Airways New Zealand submission to the Civil Aviation Authority's 2018 Nelson and Marlborough Airspace Review

**Prepared by: John Wagtendonk
Policy, Standards and Safety Improvement
Airways New Zealand**

11 January 2018

This submission requests a reduction in the size of the Nelson control zone (NS CTR) and significant changes to the Nelson control area (NS CTA).

Diagram 8 Draft CTA to the west.

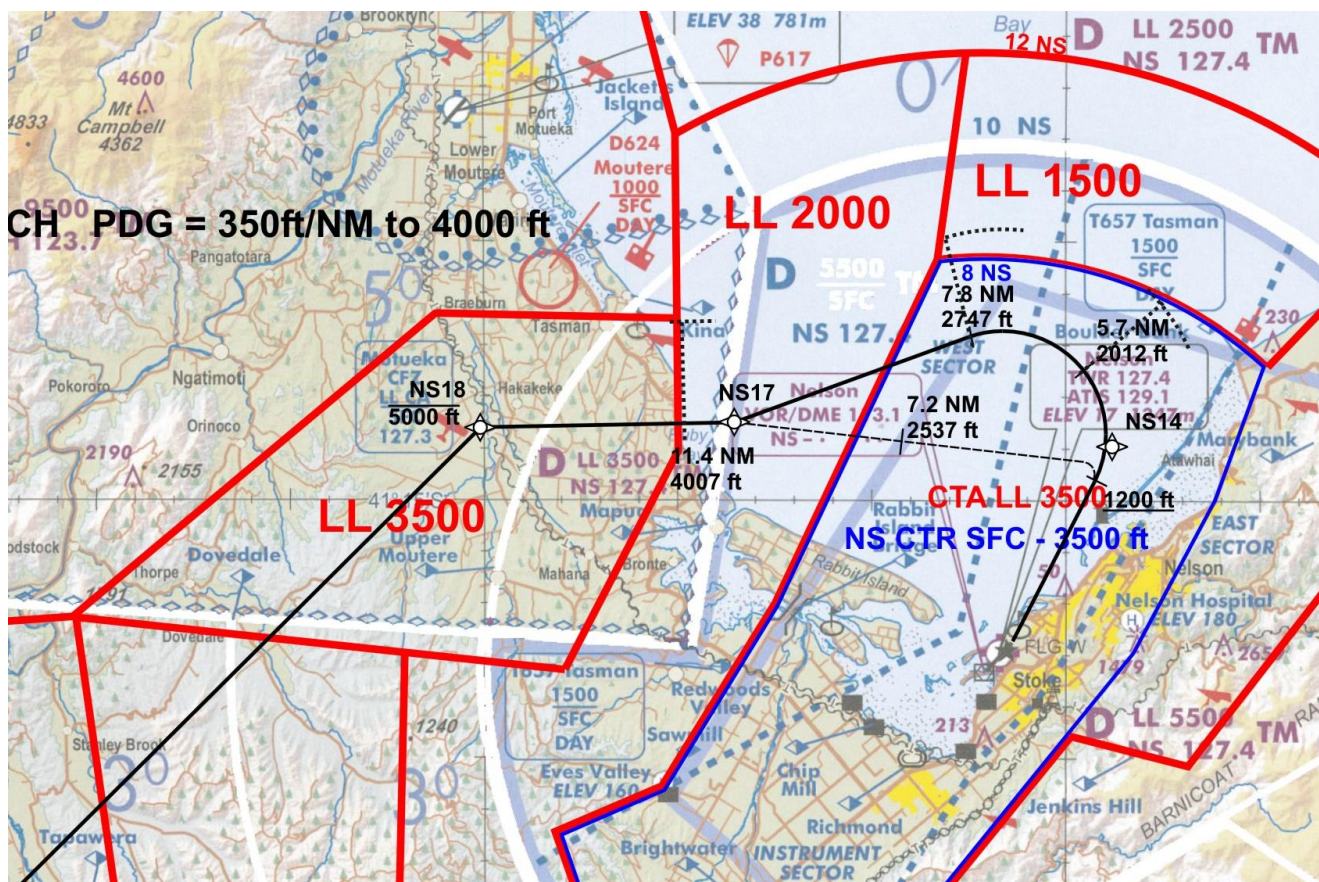
The western boundary of the CTA near Ruby Bay is primarily determined by the new PBN departure off RWY 02 to NZCH. As shown on Diagram 8, the SID passes through 4007 ft immediately prior to the coast at Ruby Bay. That is based on the published departure specifying a minimum net climb gradient of 350 ft/NM (5.8%) to 4000 ft (or steeper).

Diagram 9 Draft CTA.
Black line is the new PBN departure off RWY 20 to NZAA.

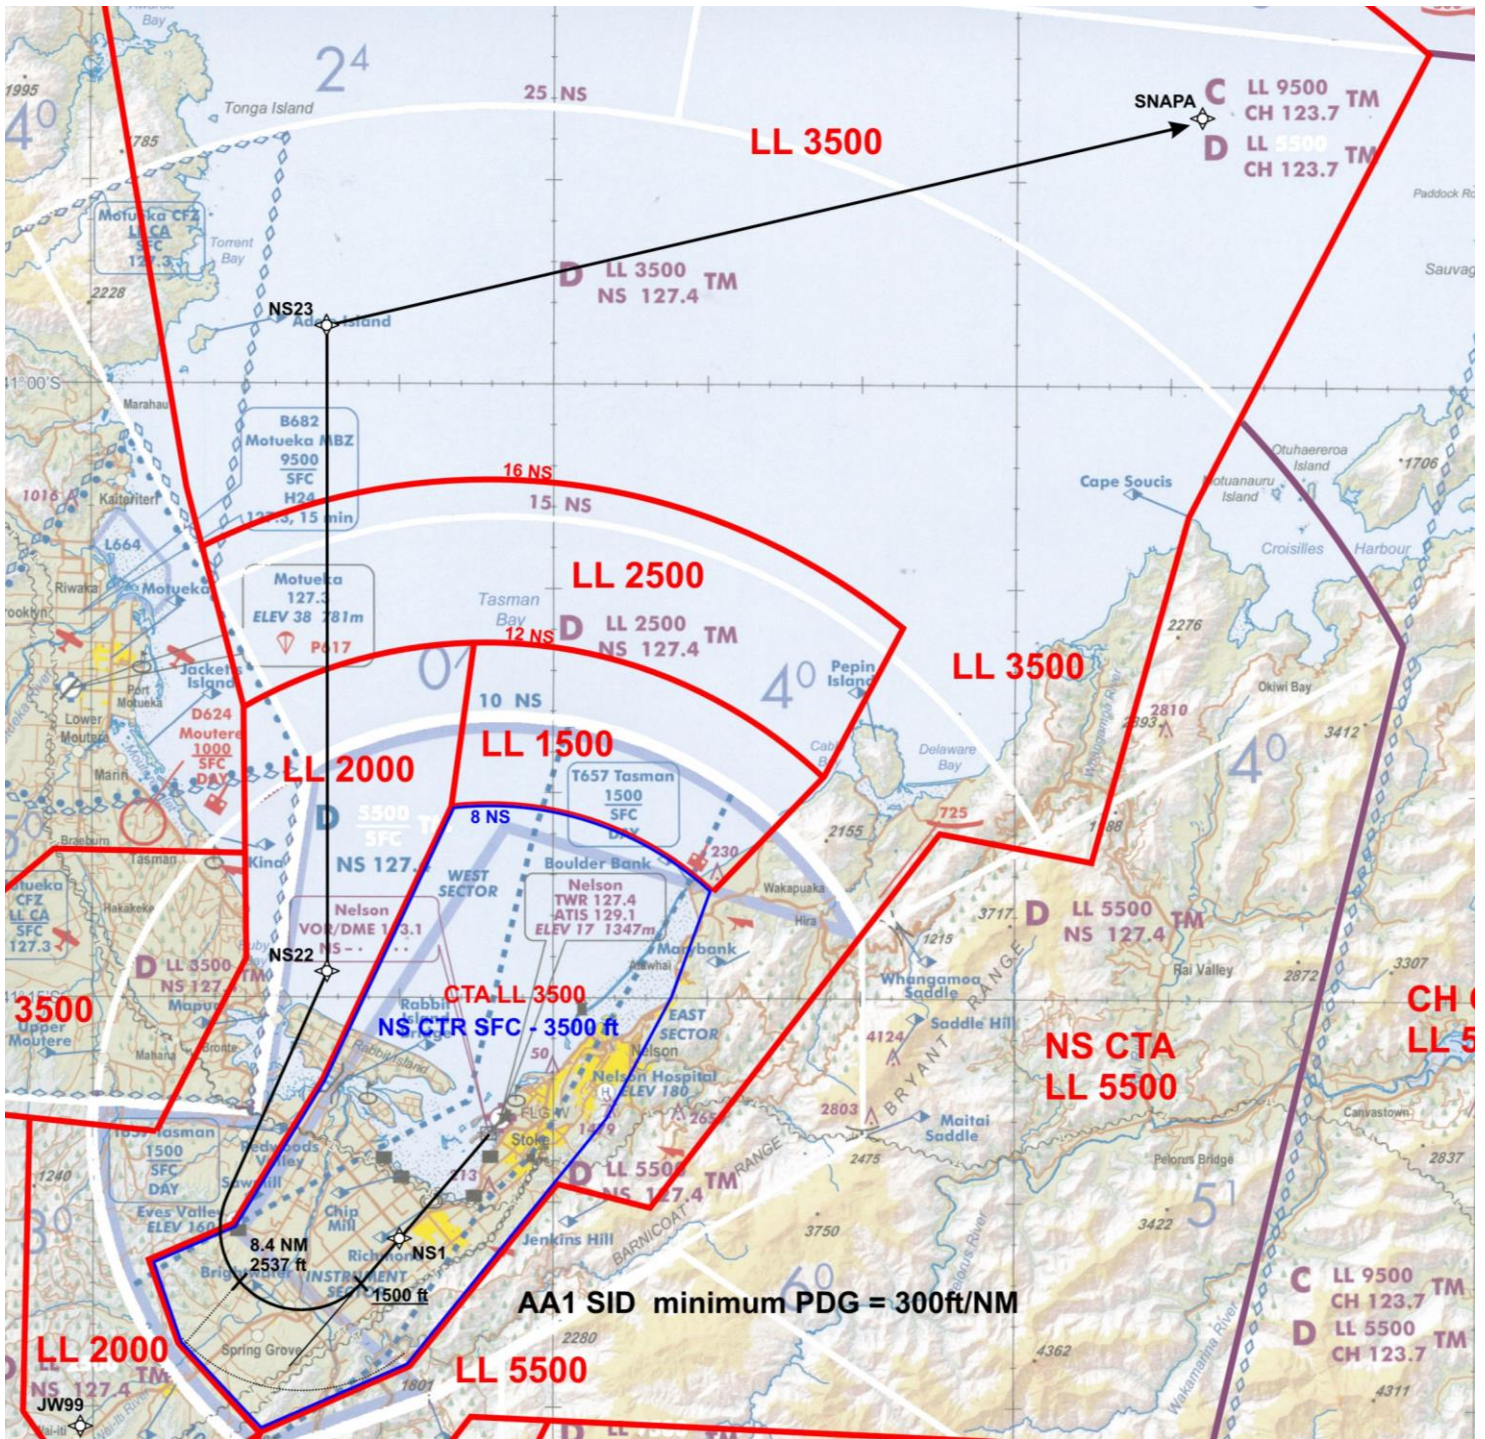
The new PBN SID to NZAA off RWY 20 is shown in Diagram 9 below. The CTA boundary near Ruby Bay provides the required 2 NM buffer from the RNAV departure.

Diagram 10 Draft CTA to the south.

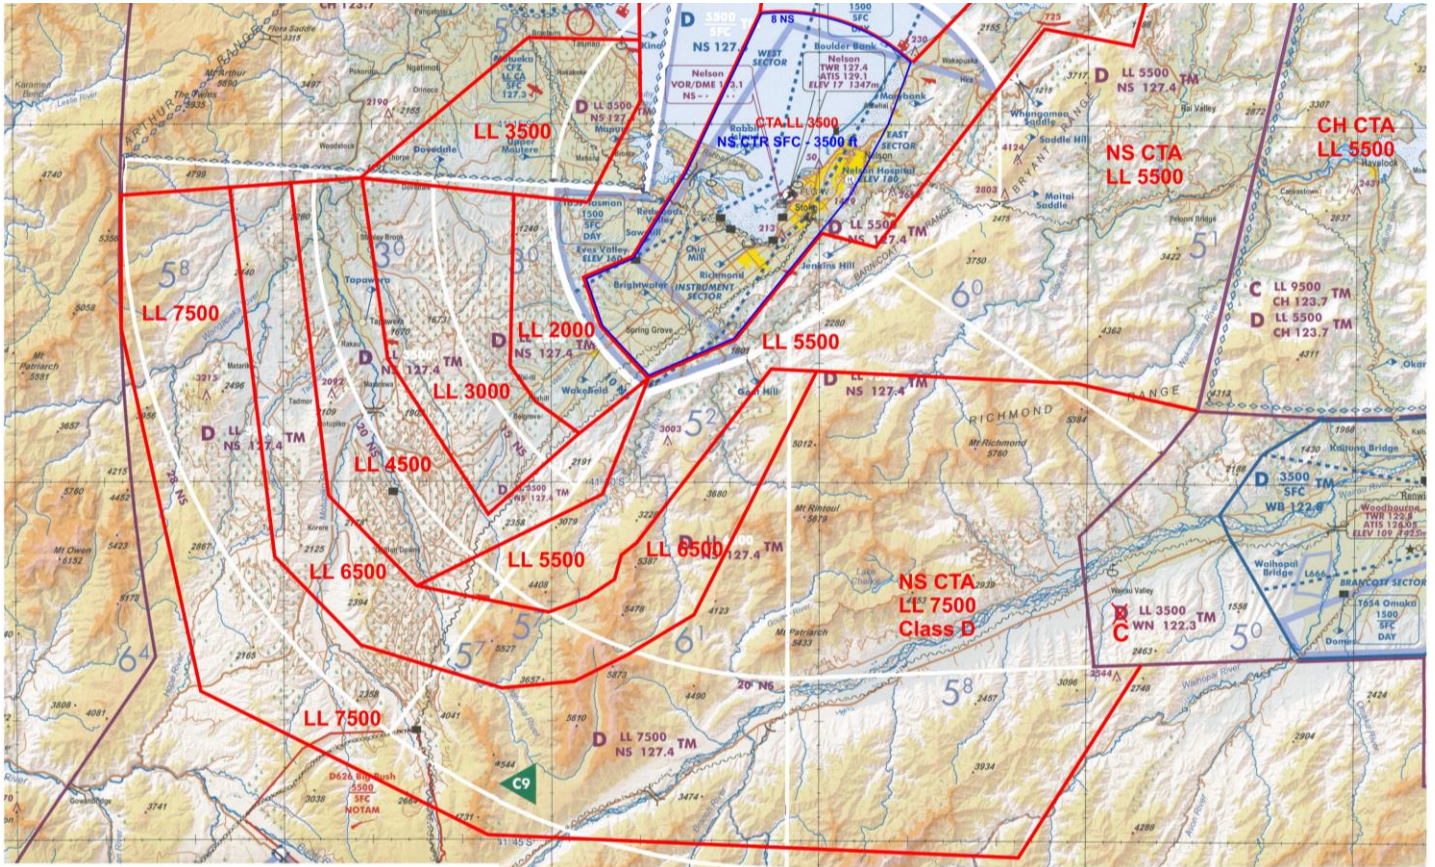
The draft CTA to the south is depicted in Diagram 10 below. This CTA is more complex than ideal due to the high and undulating terrain to the south and the airspace design rule that the lower limit of CTA must be at least 700 ft above terrain. Attempts to simplify the design by expanding a particular CTA were often prevented by a high point in the terrain that would result in the CTA be less than the required 700 ft above the terrain.

Diagram 11 Draft CTA to the south with arrival from NZCH and RNAV approach to RWY 02.

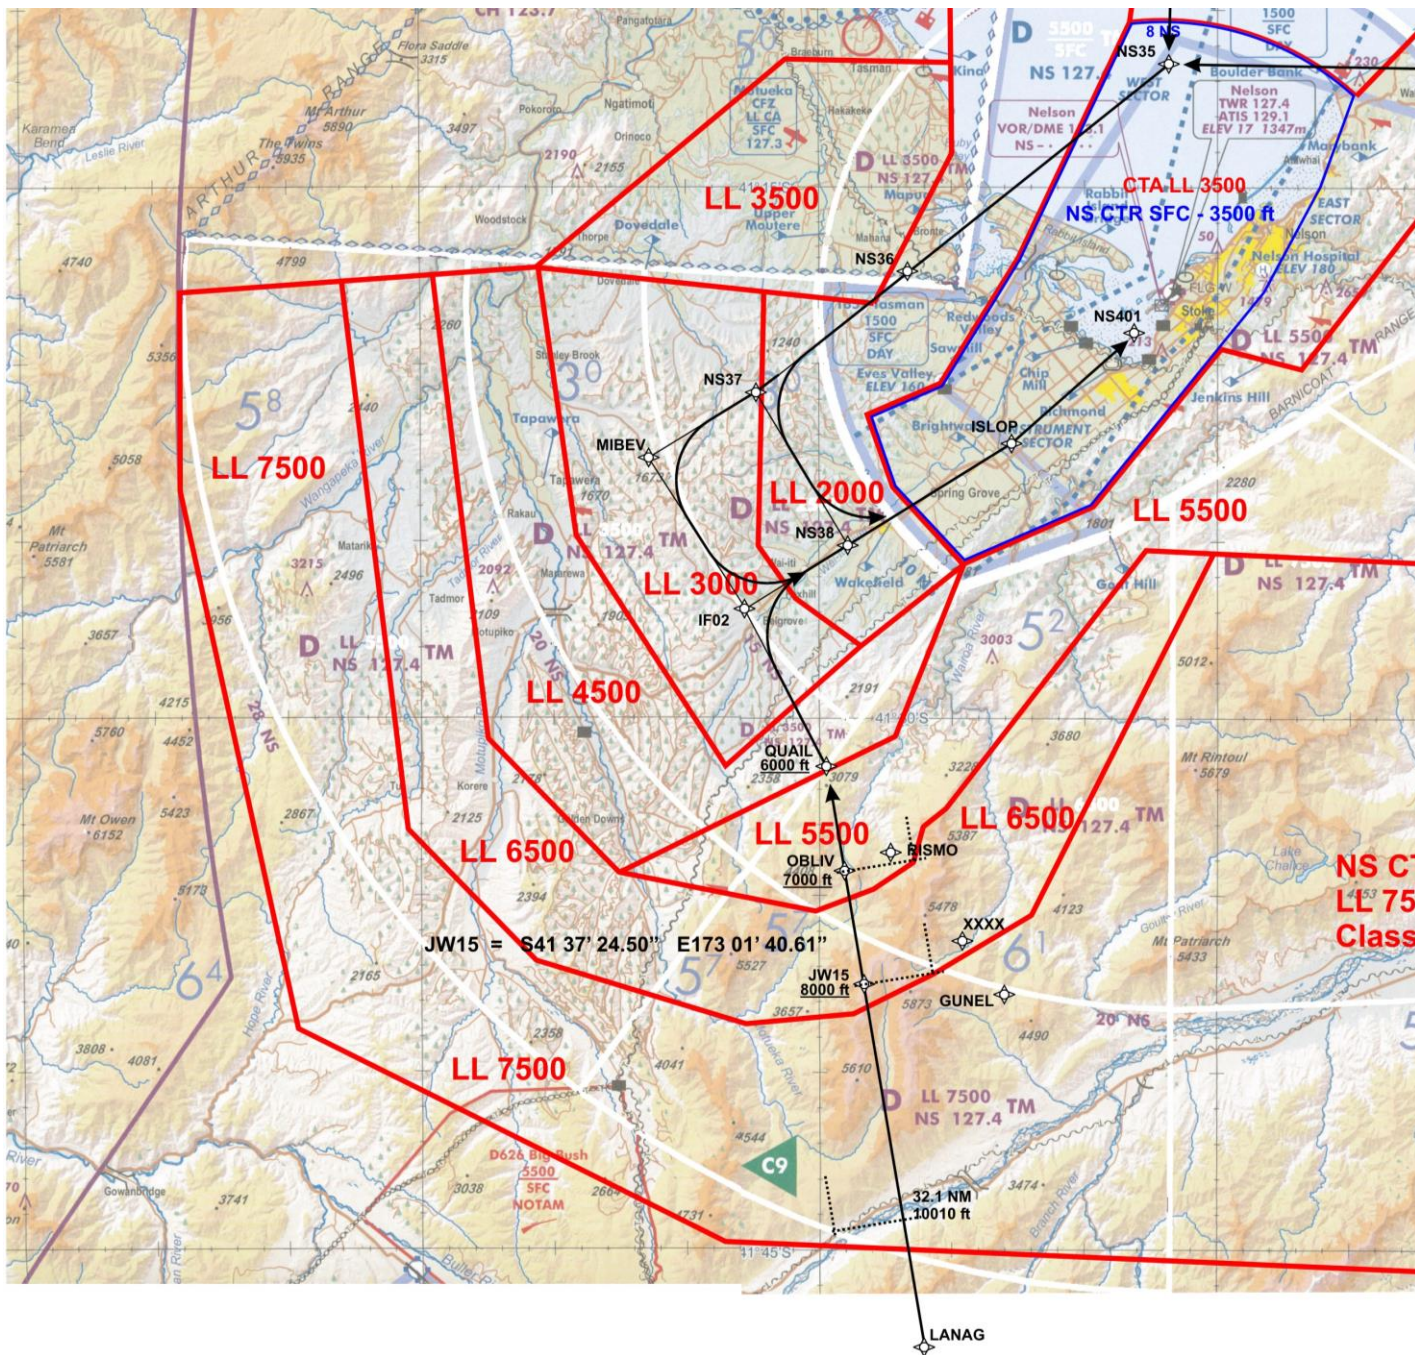
The arrival from NZCH and RNAV RWY 02 approach is shown in Diagram 11 below. Distance and altitude checkmarks are shown along with the extent of the required 2 NM buffer near the checkpoint. Diagram 12 depicts an alternative arrival from NZCH still being worked on. This draft CTA allows for this alternative arrival.

The CTA LL 4500 ft that wraps around the east of the 2000 ft and 3000 ft CTA is needed to contain the RNAV RWY 02 approach from QUAIL.

Diagram 13 Draft CTA to the south with arrival from NZWN, including new holding pattern at 'ALICE', and RNAV approach to RWY 02.

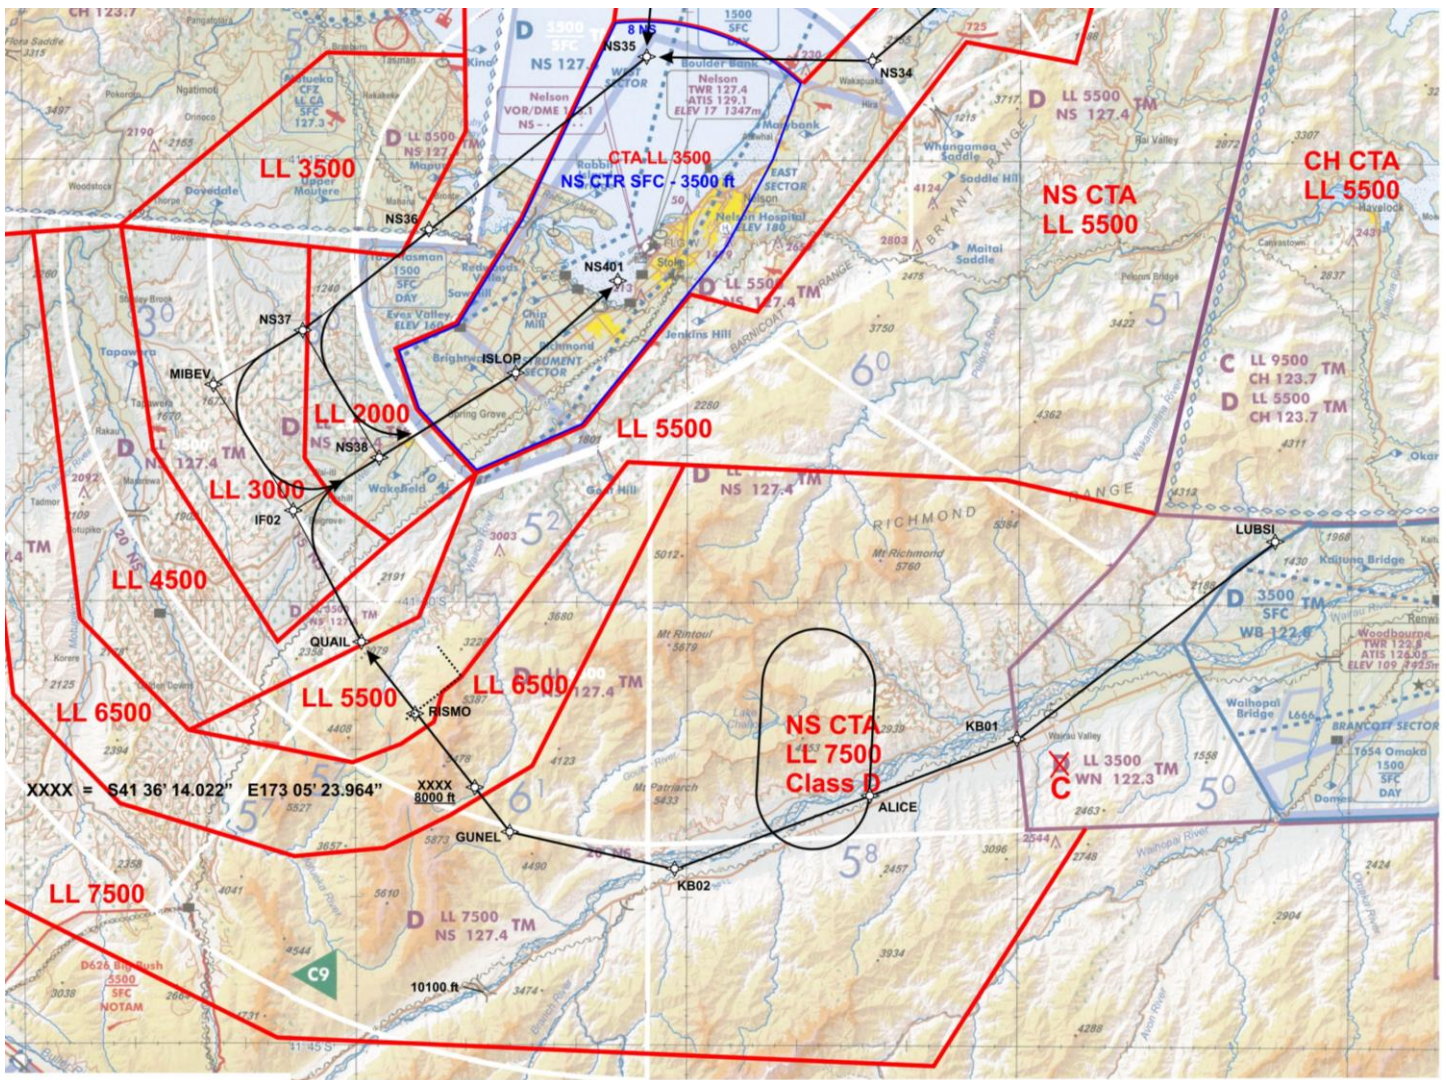
Diagram 13 below depicts the RWY 02 arrival from the east with the planned new holding pattern at new waypoint 'ALICE'.

The CTA LL 7500 ft is expanded south to correctly contain the ALICE holding pattern.

Diagram 14 Draft CTA to the south with RWY 20 departures to WN.

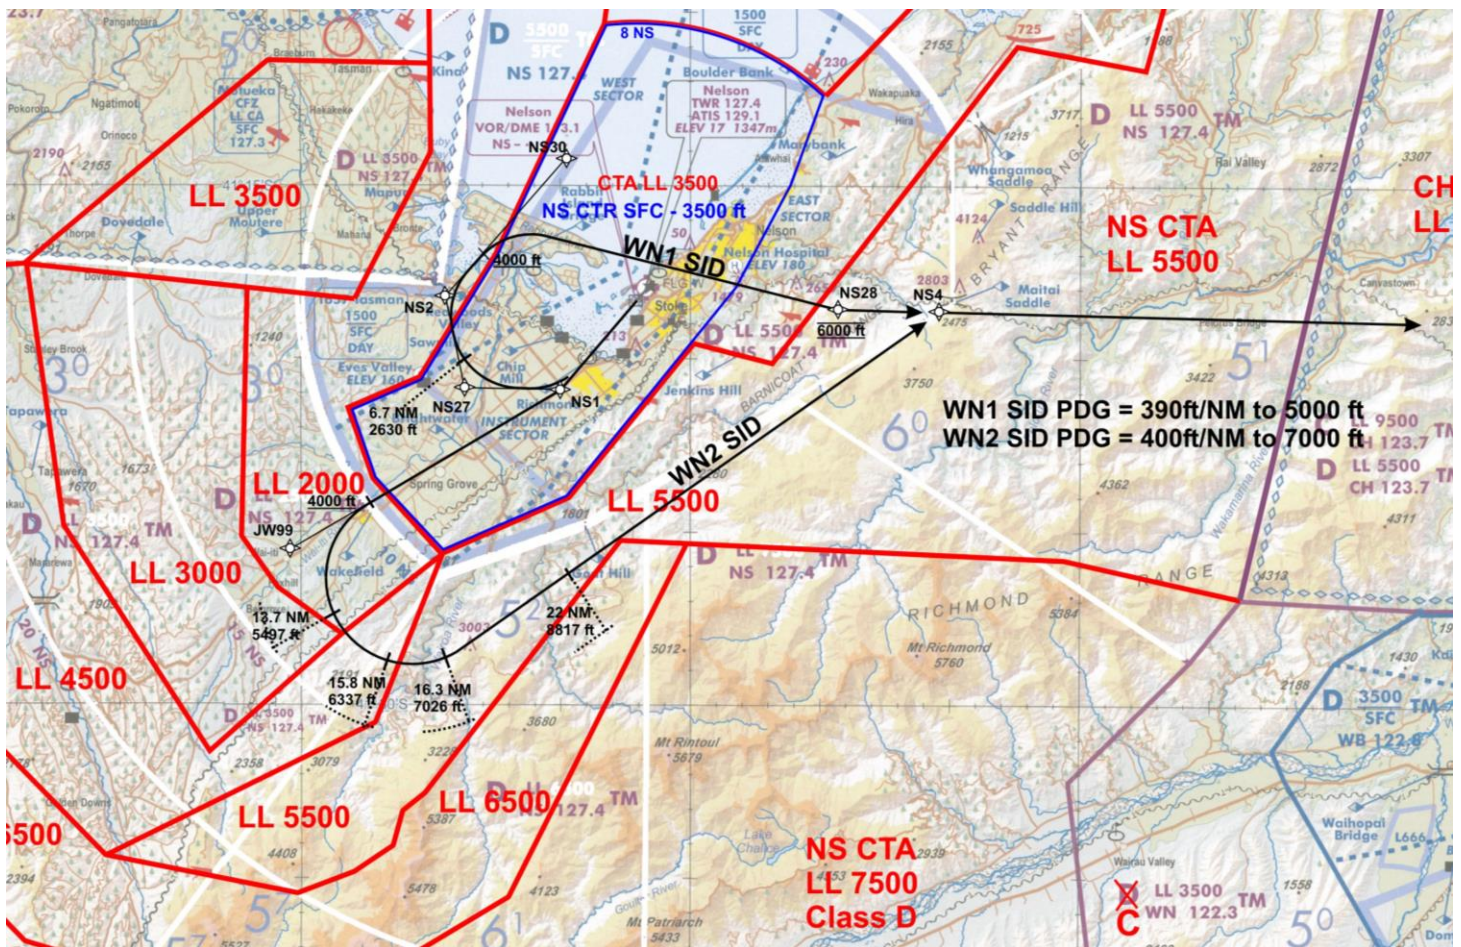
The CTA LL 5500 ft and LL 6500 ft to the south of Nelson is needed to contain the departure to NZWN off RWY 20 that turns left after passing 4000 ft.

Diagram 15 The WB CTA that we are requesting classification change to Class C.

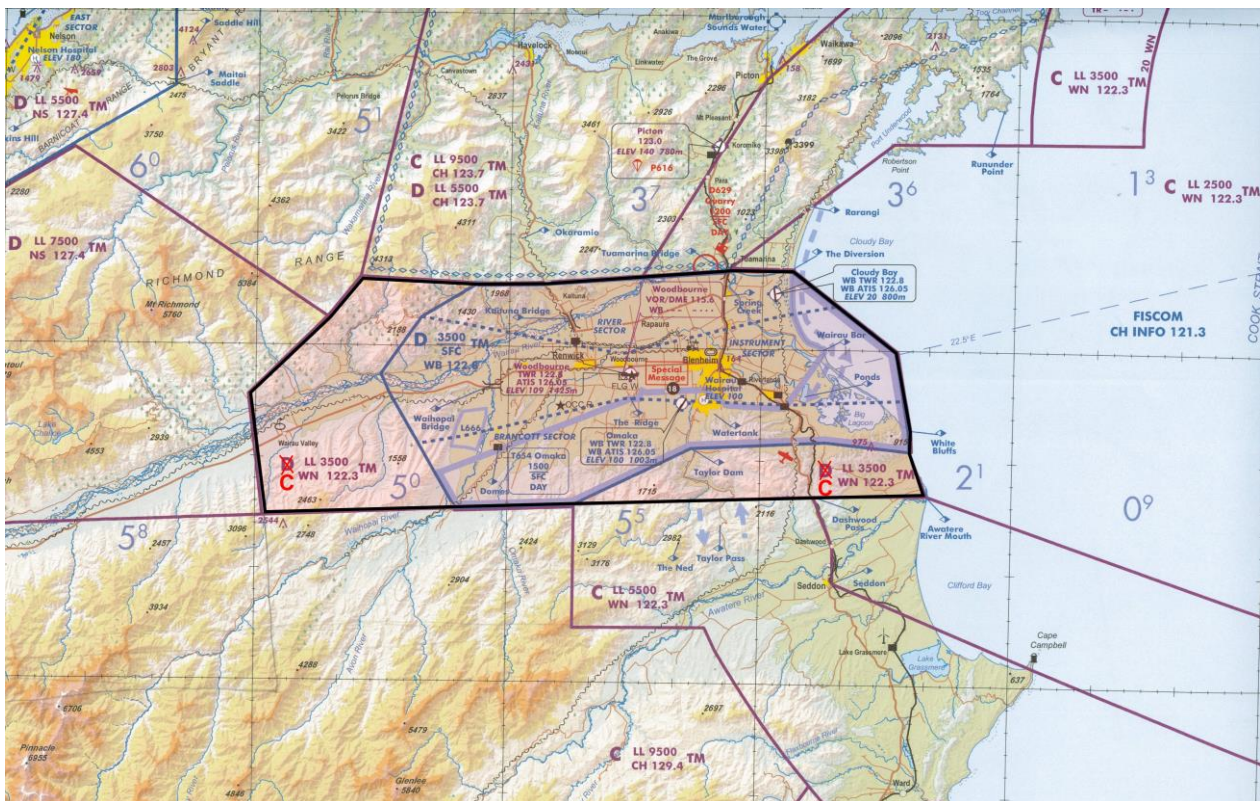
Separate to the requested Nelson airspace changes, Airways is requesting that the WB CTA 3500 ft to 9500 ft (NZA631), red highlighted in Diagram 15 below, is changed in classification from Class D to Class C.

This CTA block is controlled by WN Approach. All the CTA controlled by WN Approach around this particular CTA is Class C.

Changing this CTA block to Class C would enhance consistency of ATC service.
